Product Change Notification (PCN)

PCN #: 6A-2026

Date: June 2nd 2026

5.1 Designator R41

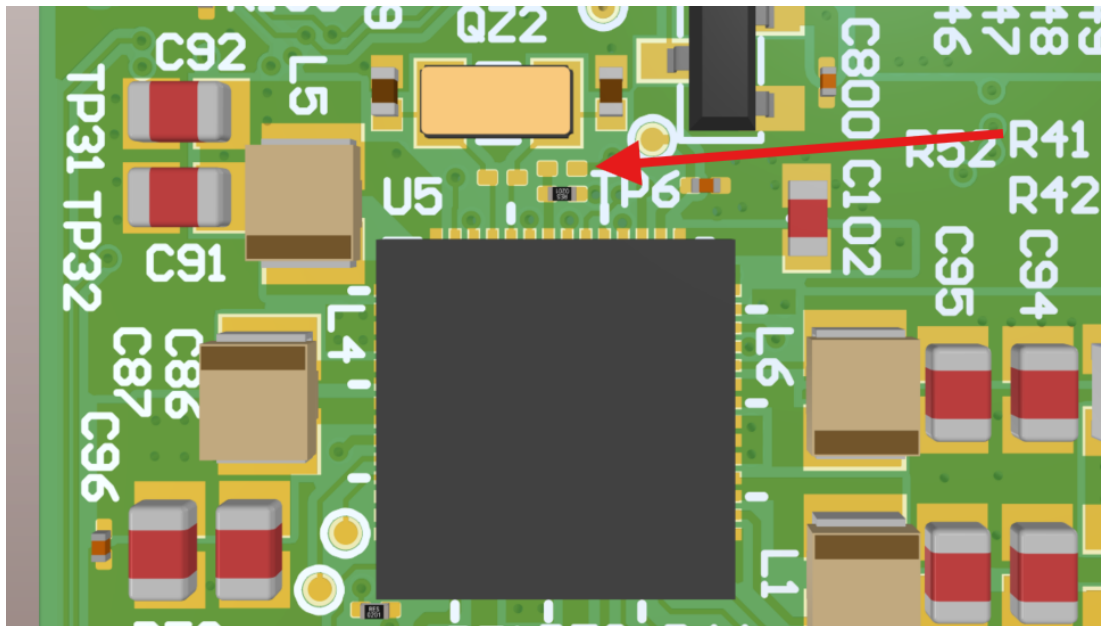
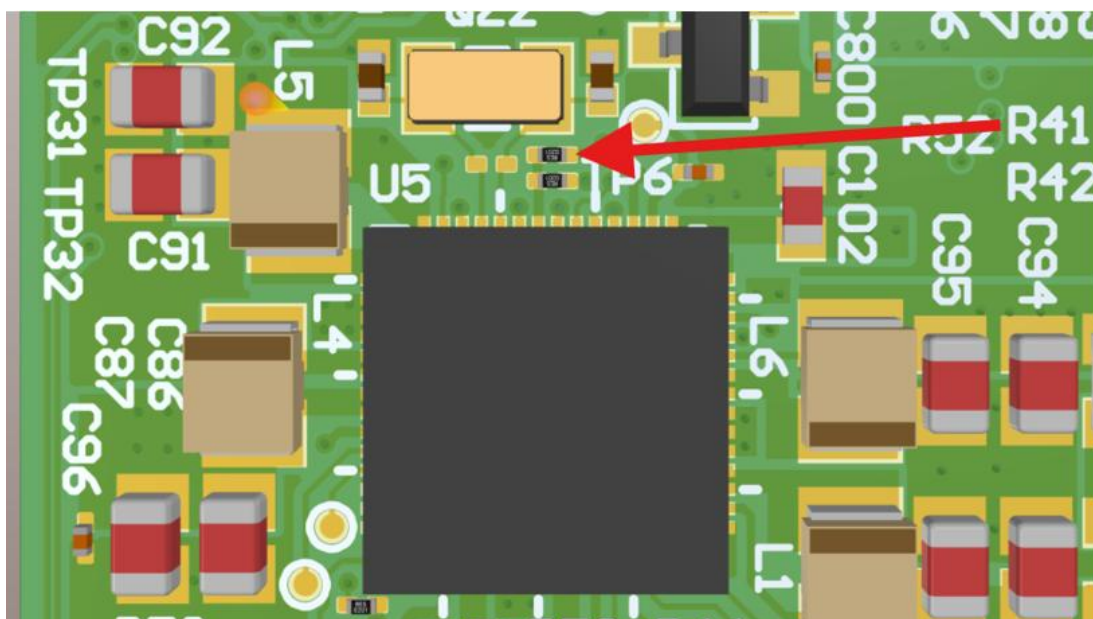
R41 will be populated with a 10 kΩ resistor.

D4 will be changed from BAT54CLT1G to SDM40E20LC-7

- Old REV (R41 not populated)

- New minor REV (R41 populated)
